ECE3301L SESSION 1
LAB 3

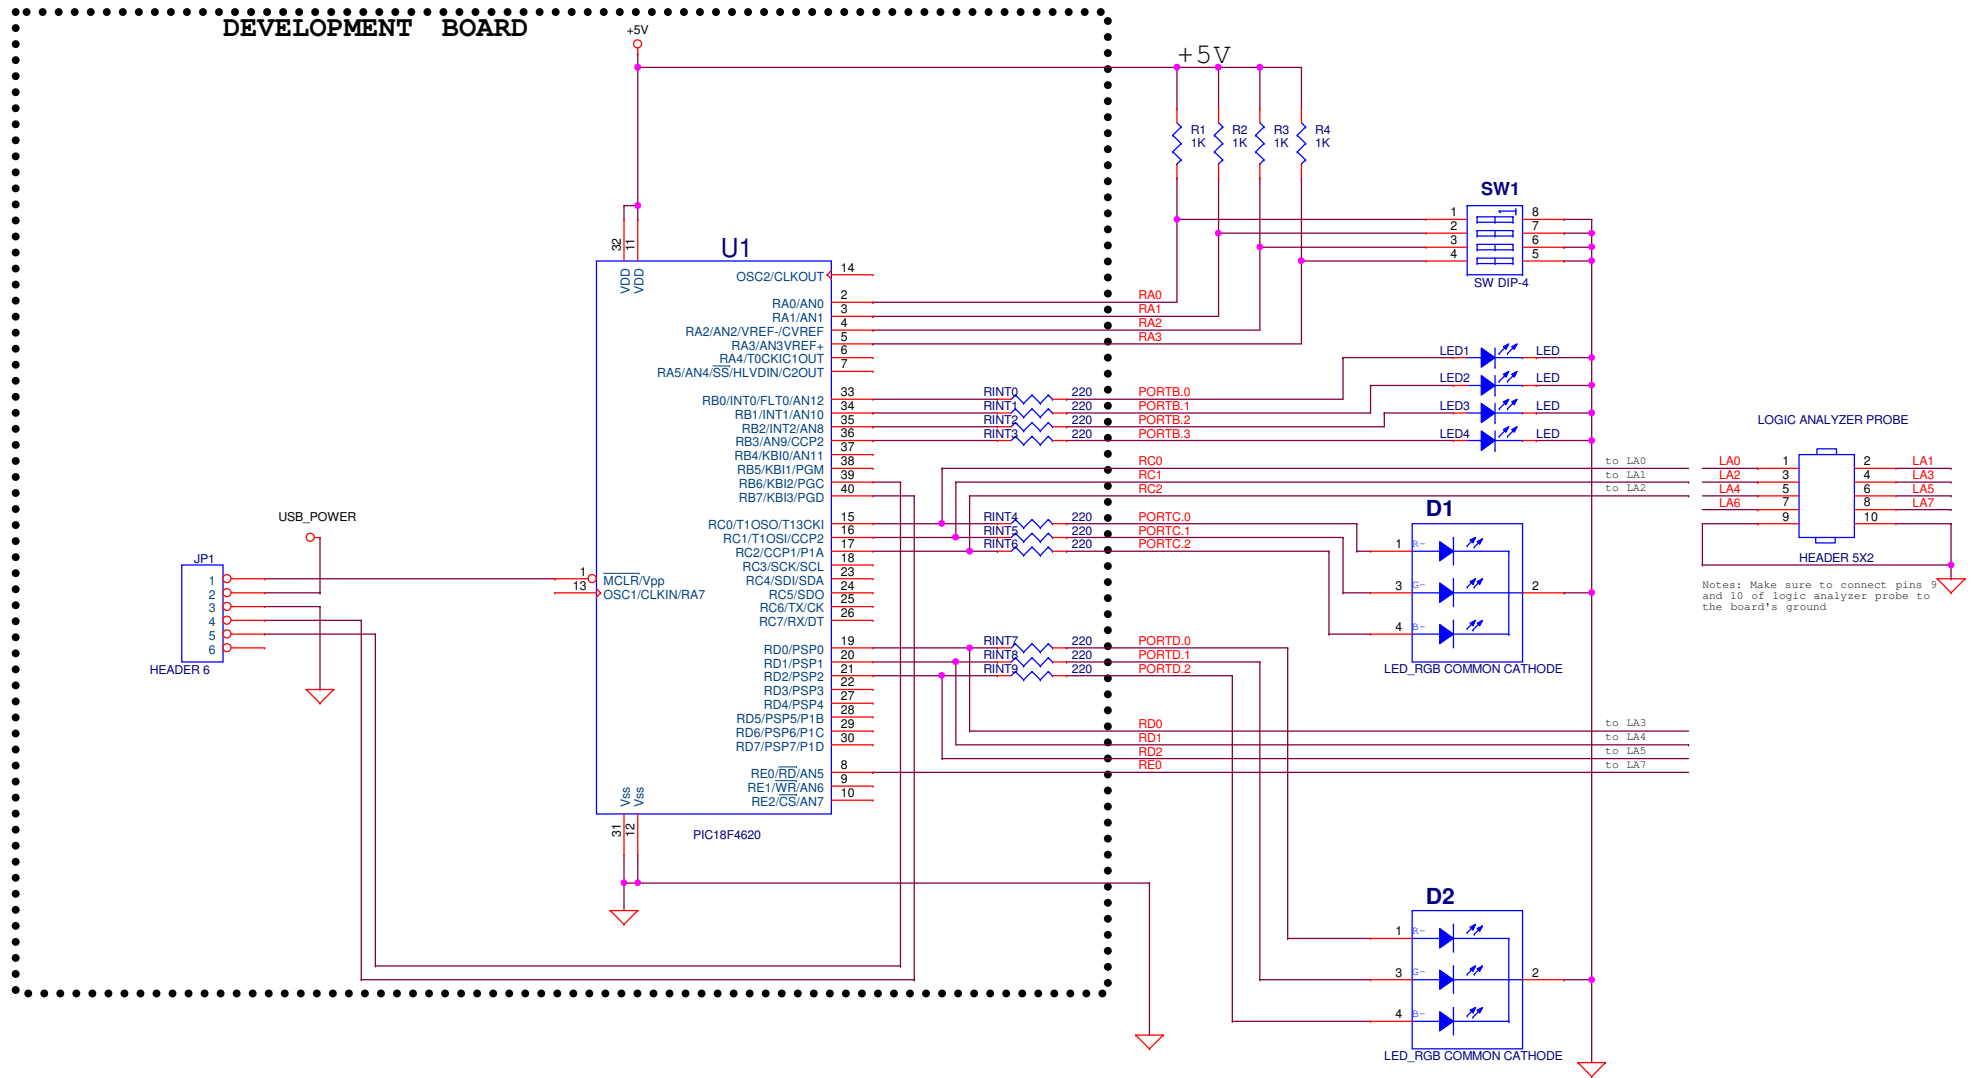
REMOVE THE JUMPER AT JP3 THAT IS CONNECTING PIN 1
TO 2 AND MOVE IT TO CONNECT FROM PIN 2 TO PIN 3.
THIS WILL ALLOW THE SIGNAL 'RA3' TO WORK PROPERLY.
